BEVERIDGE NORTH WEST PRECINCT STRUCTURE PLAN – HAZELWYNDE

Yarra Valley Water's submission to the
Victorian Planning Authority

The Victorian Planning Authority (VPA) has prepared Amendment C106 to the Mitchell Planning Scheme (Mitchell Shire Council).

The following is Yarra Valley Water’s (YVW) submission to the VPA as the landowner of Hazelwynde, 740ha of land within the Beveridge North West PSP (BNWPSP) area.

Figure 2 – Alternative Future Urban Structure Plan

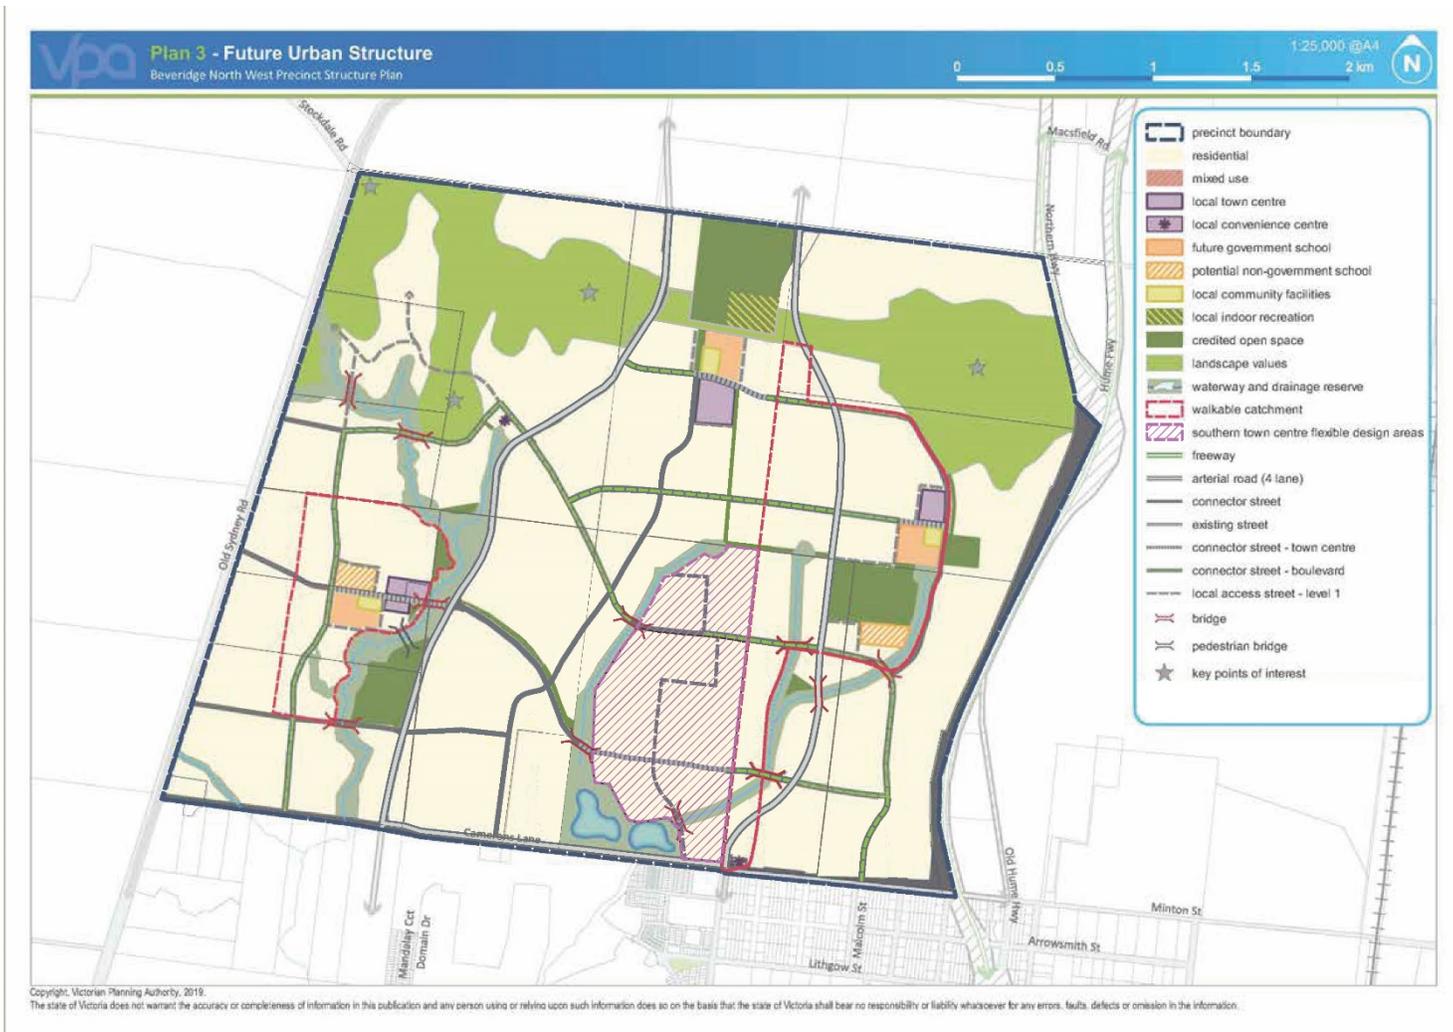
While YVW is generally supportive of the intent of the FUSP, there are several elements on the FUSP which YVW would like to discuss in more detail with the VPA. These include:

Mesh, as part of their review of the exhibited document provides an alternative FUSP for consideration which addresses the above items. Refer figure 2 below.

Figure 3 – Southern Local Town Centre Design Options

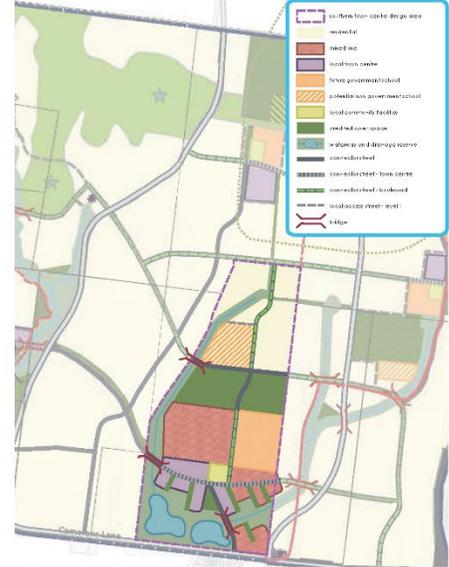
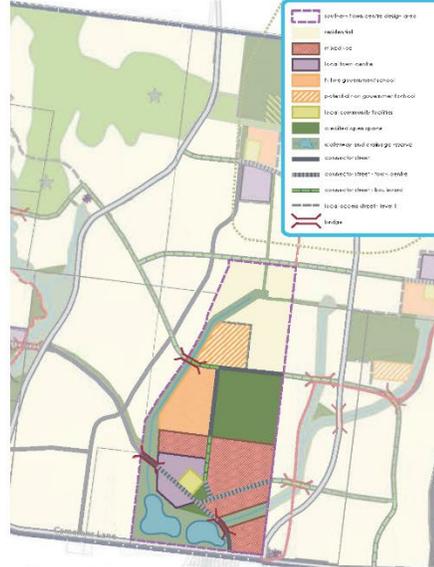
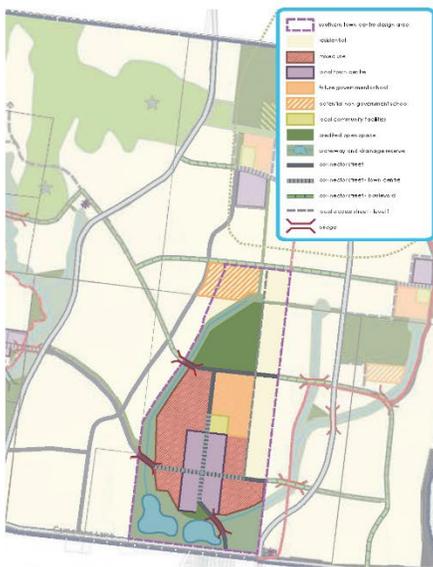
- The prescriptiveness of the local town centre ‘shapes’ – such as the location of schools, open space, town centre and mixed-use shapes. To reflect the above PSP objectives, employment targets and the intent of creating a town centre which is locally responsive, we request more flexibility in the PSP document, specifically the FUSP, to the location of these items. The location of these items should be determined through the master planning phase and in conjunction with stakeholders and their needs. Refer Figure 3 below.

Figure 1: Proposed Street Network Modifications

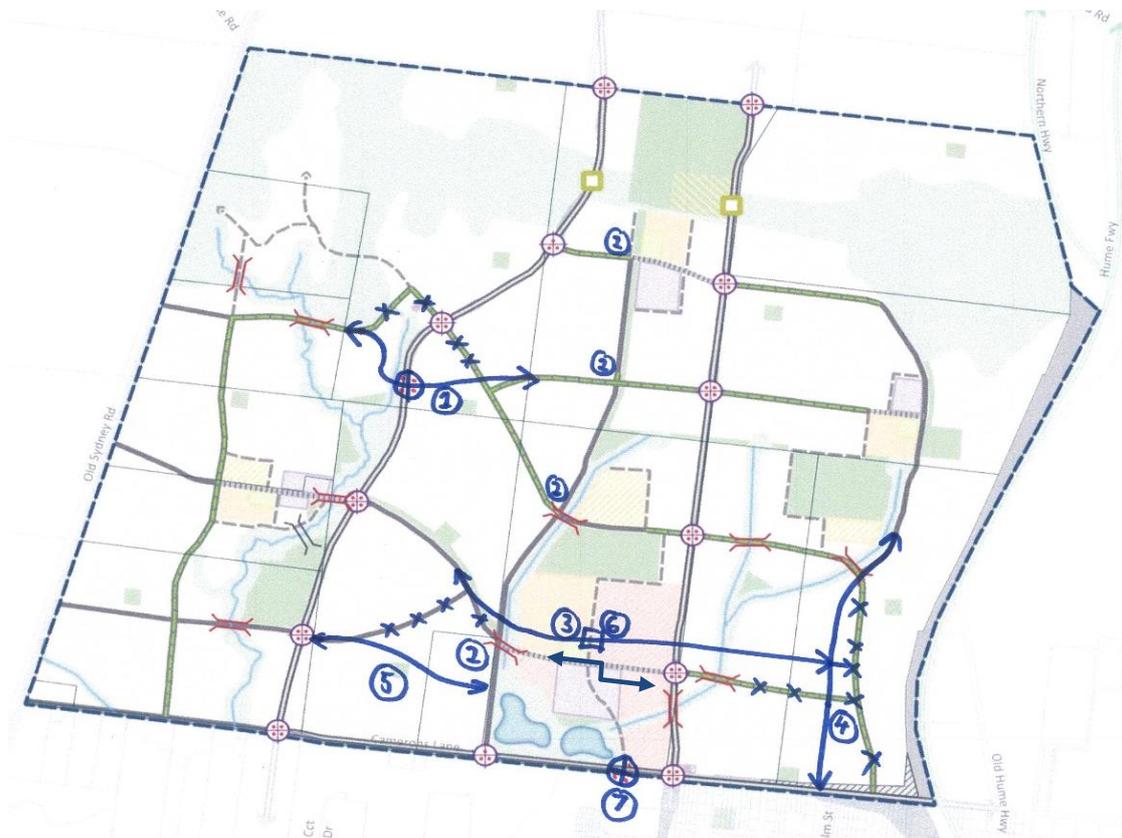
- c. Consideration should be given to making the following street network changes. Refer also Figure 1 below for proposed changes in the same number format as the comments below.

- A signalised intersection should be provided within the LTC to improve pedestrian accessibility between the LTC and School/ Community site.
 - As per comment 4 c. above provide a second access point into the LTC via a signalised T-intersection to separate the LTC traffic from the Patterson Road through traffic.

Figure 17 - Old Sydney Road Cross Section (Source: Mesh)

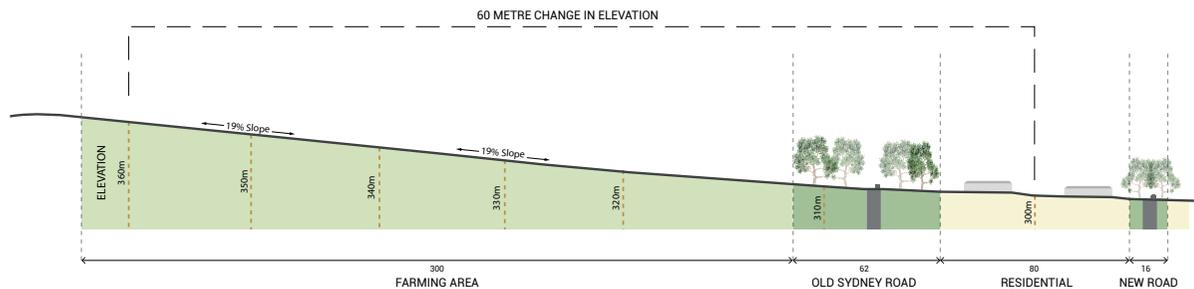
The Old Sydney Road interface is problematic in this regard. The exhibited PSP prescribes an average lot size of 736m² for this interface but Table 2 restricts the development outcome to a single dwelling with a minimum 10m setback to Old Sydney Road with a building height that should not exceed 1 storey above ground. Analysis of the topography on the east and west sides of Old Sydney Road (*see Figures 17*) reveals that the landform on the west side of Old Sydney Road rises sharply well above Old Sydney Road and any built form that will be delivered in the future. Taking into account the landform it is unlikely that there will be any visual impact associated with development on the east side of Old Sydney Road and there is no need to restrict development to one storey.

Figure 22 - Alternative Future Urban Structure (Source: Mesh)

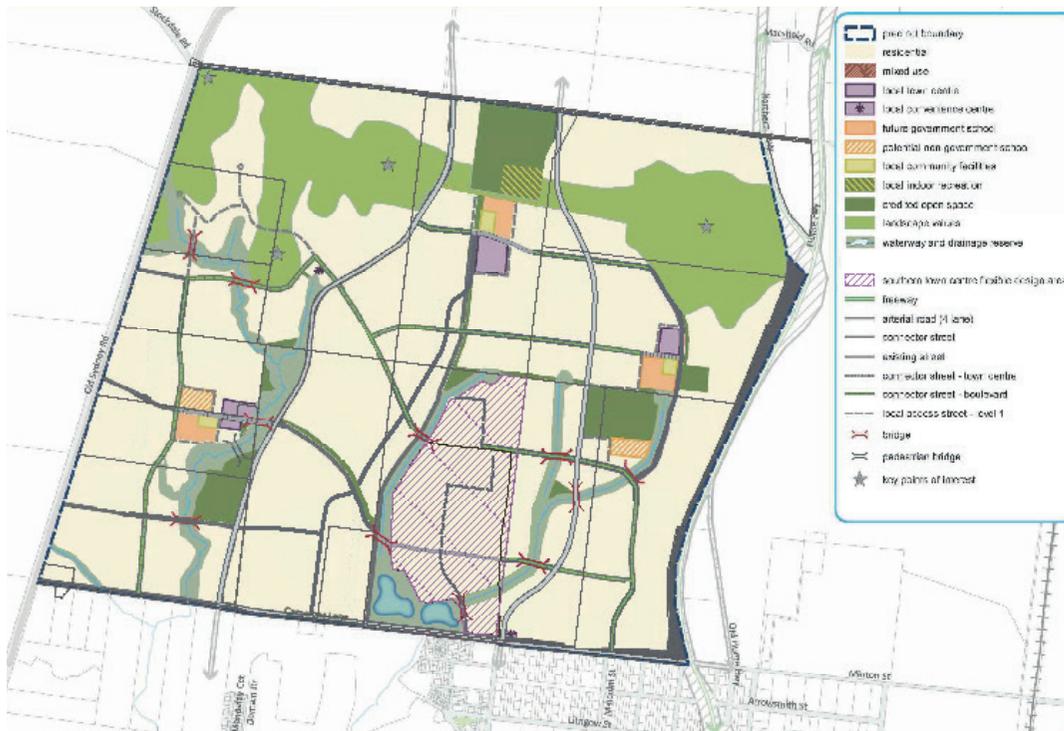
proposed town centre to create a continuous green link that will also convey water (see Figure 21). The value of this continuous green link will be diminished if it is severed by a 28-31m road with access control on both sides. The place making potential of the continuous green loop is significant particularly if it is activated by diverse housing forms and other uses noting that the western section of the loop adjoins the town centre. The PSP transport network could be improved by realigning the western arterial road to the west enabling the walkable catchment of the town centre to be consolidated and avoiding the

need to sever the green link (see Figure 22).

The exhibited alignment is problematic as it follows a property boundary as it approaches Camerons Lane and as it continues further to the north running parallel to the drainage line/open space link the connector road cross section of 28-31m will separate people from the amenity and it is likely that higher vehicle speeds will result. In order to overcome these issues and to provide a second gateway opportunity for the YVW land, the connector street could be realigned to the west as is generally depicted in Figure 22.

- › Realign the western arterial road in order to consolidate the walkable catchment of the town centre and consolidate the value of the green line without the need for it to be crossed by an arterial road;
- › Consider the opportunity to downgrade the northern part of the western arterial road and/or the eastern arterial road to connector streets; and
- › Realign the western north-south connector within the YVW land such that it does not adjoin the drainage line/open space link with a new intersection on Camerons Lane (see Figure 22).
